ADDENDUM NO. 3

REPLACEMENT OF THAMES STREET WALL AT ELECTRIC BOAT GROTON, CT

MMI #2536-13
December 6, 2019

RETAINING WALL - PLAN
SCALE: 1"=10'-0"

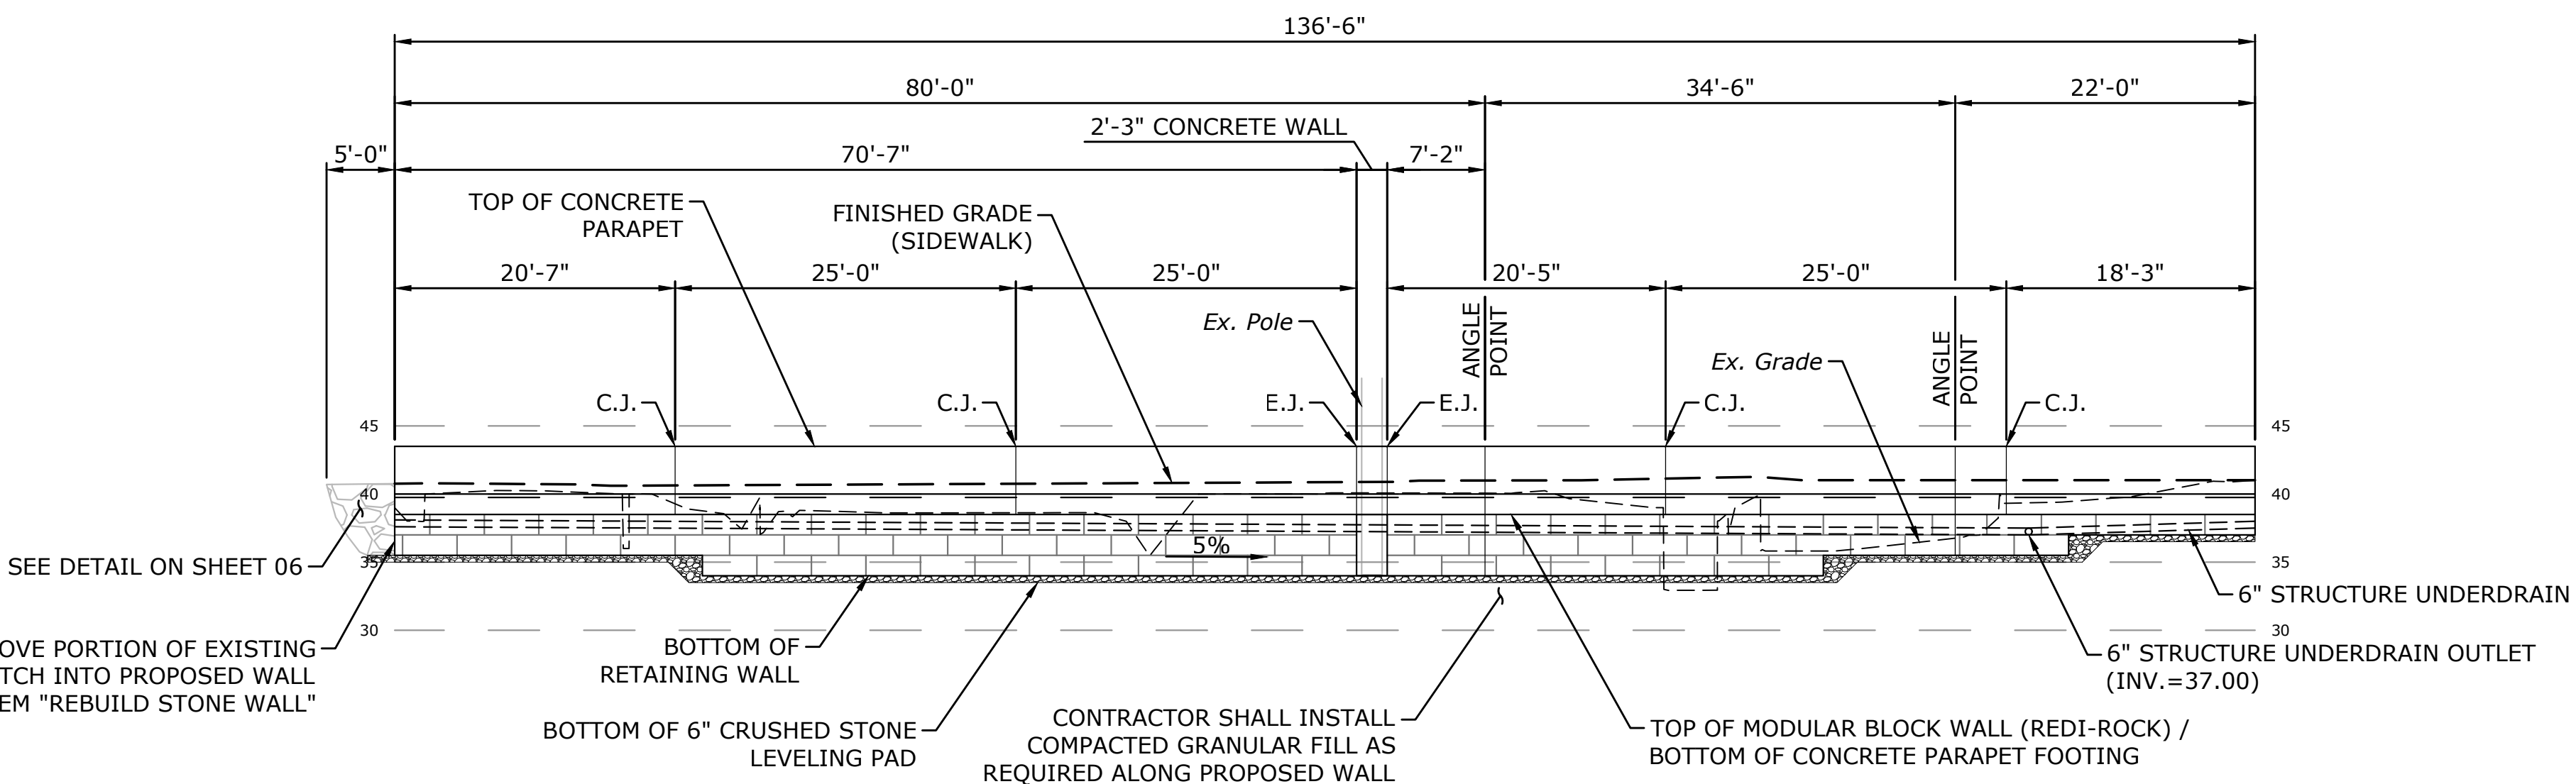
Q2: What are the pay limits for Item #214000 "Compacted Gravel Fill"?

Q5: What are the pay limits for Item #728016 "3 Inch Crushed Stone"?

R2: The item is for contractor to bring up grade under the footings of embankment wall necessary to maintain the bottom of wall shown on the elevation view on sheet STR-01.

R5: See sheet STR-01 on bottom left hand corner under Legend the hatched area is the limits for 3" Crushed Stone.

MODULAR BLOCK UN-REINFORCED WALL

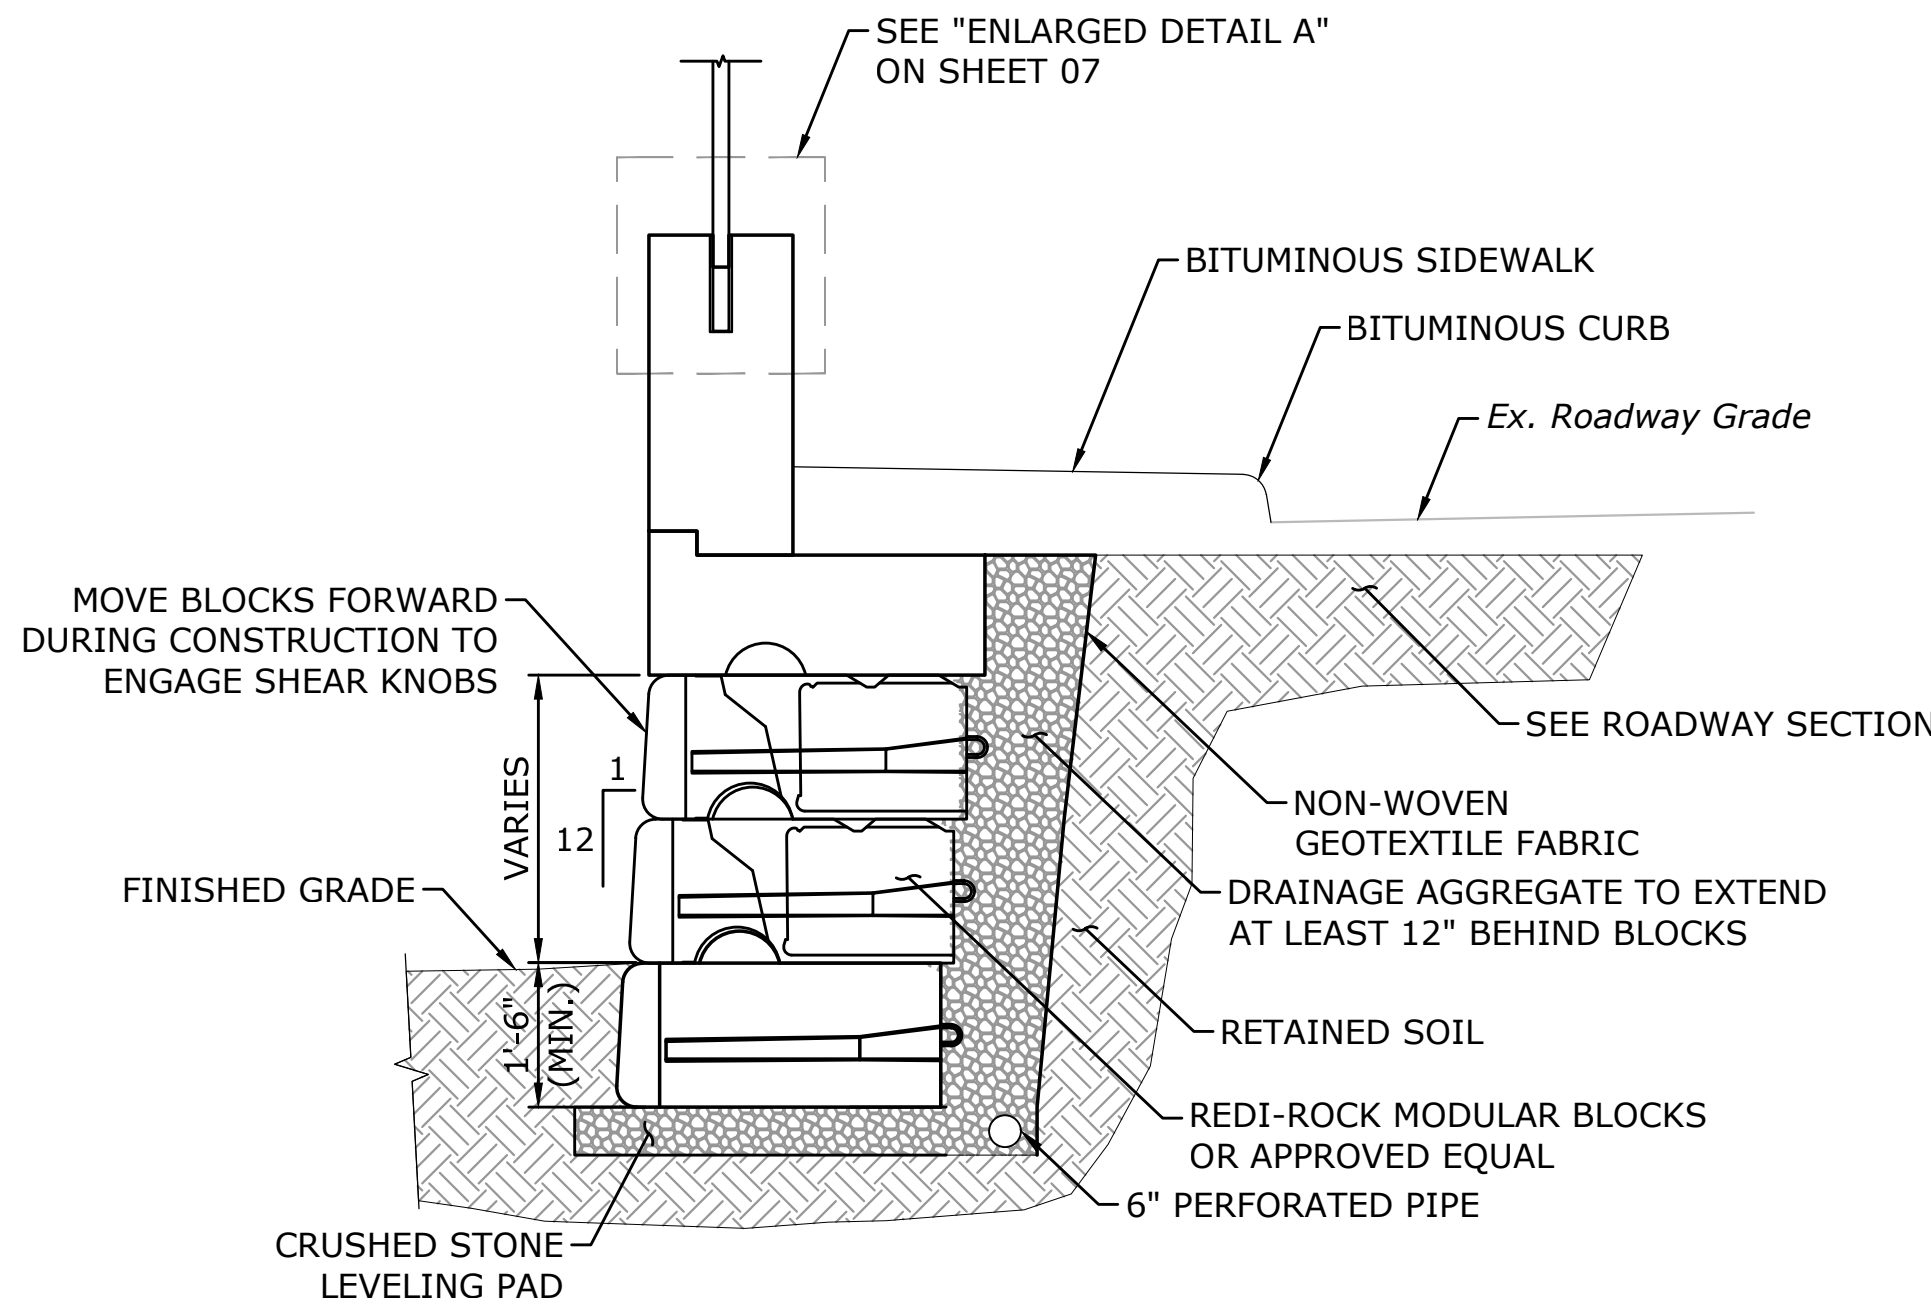
Q4: What are the pay limits for Item #728014 "3/4 Inch Crushed Stone"?

Q21: Please clarify what is to be included in the item for Embankment Wall (Site No.1). There are additional items listed as unit price items that are also included within the Lump Sum item for Embankment Wall (Site No.1). Please Clarify.

R4: See "Modular Block Un-Reinforced Wall Section" on sheet STR-02, the 3/4" crushed stone shall be the crushed stone levelling pad and drainage aggregate behind the blocks.

R21: The excavation will be paid under item “Structure Excavation – Earth (Complete)”. The Leveling Pad and Drainage aggregate shall be paid under item “3/4” Crushed Stone”. All other items to complete the wall shall be included in the item “Embankment Wall (Site No. 1) i.e. the blocks, installation of blocks, geotextile fabric, pervious structure backfill, labor, and etc.

REMOVE & RESET EXISTING STONE WALL

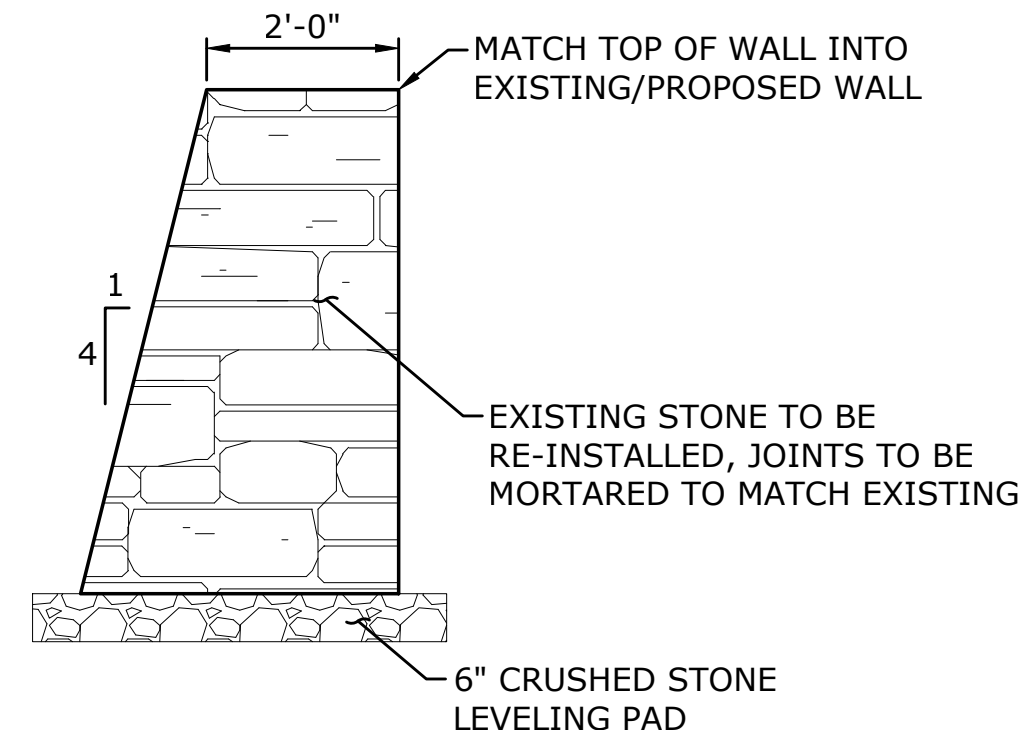
Q16: Please provide the special provision for Item #905018A – Rebuild Stone Wall.

R16: A detail has been provided on sheet STR-02. The “A” has been removed from the item number.
